Overview: Mis-Wired door lock connector, field repair required.

Issue: A review of the latest samples of **FTI-TLP4 T-harnesses** has revealed a misplaced trunk output wire in the 6-pin Lock Accessory Connector requiring that the wire be relocated to the correct position, to ensure safe operation when used. **Using the harness without addressing the issue will result in failed trunk/hatch control, and possible damage to the vehicle BCM.**

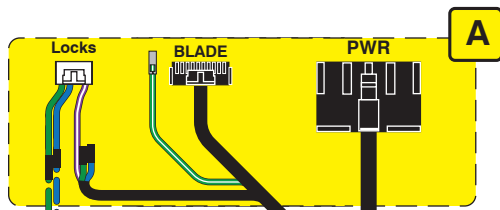
Correction: The harness purple/white wire in the latest production run of FTI-TLP4 harnesses has been inserted in the position normally used for the +12V power connection in the accessory harness. Before completing the installation, the installer must relocate the harness purple/white wire to the correct position, 1 space inward on the 6-pin connector, see illustrations below in Fig. 2.

To relocate the terminal, using a fine pick or Olfa type knife, depress the terminal locking barb and pull the purple/white wire from the connector housing. Once the terminal has been removed from the housing, again using the pick or knife, lift the locking barb about 1/16" (1.5 mm) and reinsert the terminal in the correct position. If upon initial examination of the harness the lock accessory connector looks like the illustration in Fig. 2, no modification is necessary, the wire is in the proper position.
